From: [REDACTED]@maxfordham.com [REDACTED]@maxfordham.com]
Sent: 07/11/2013 15:40:32
To: Hanson, Paul: PC-BlgCtrl [REDACTED]@rbkc.gov.uk]
CC: [REDACTED]@maxfordham.com [REDACTED]@maxfordham.com; [REDACTED]@exova.com; Grenfell [grenfell@studioe.co.uk]; Bruce Sounes [REDACTED]@studioe.co.uk]
Subject: Grenfell Tower - Smoke exhaust LFB submission.

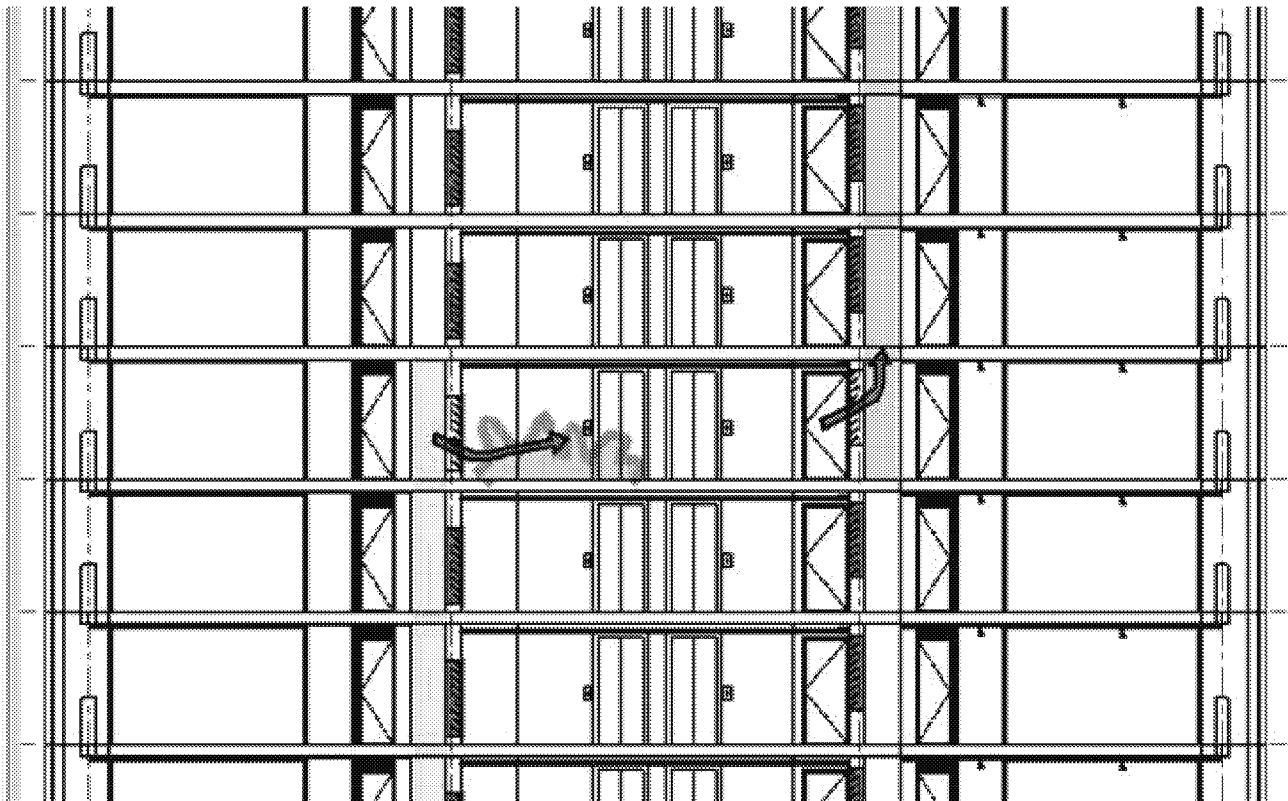
1. “..is designed .. as a natural ventilation system...” (line 2) is followed by “a mechanical supply and extract system which does not rely on natural ventilation” (Smoke Control, second para). His initial response is that this reads like we are omitting a compliant natural vent shaft. We could just leave the ‘compliant’ system as it is at present, but we (and Exova) think it would be better to provide a more predictable system with mechanical supply and extract as the default mode, all as described in the ‘Proposed System’ part of our report.
2. Some diagrams would be useful. I have attached our schematic drawing and Studio E have provided the visual representation below.
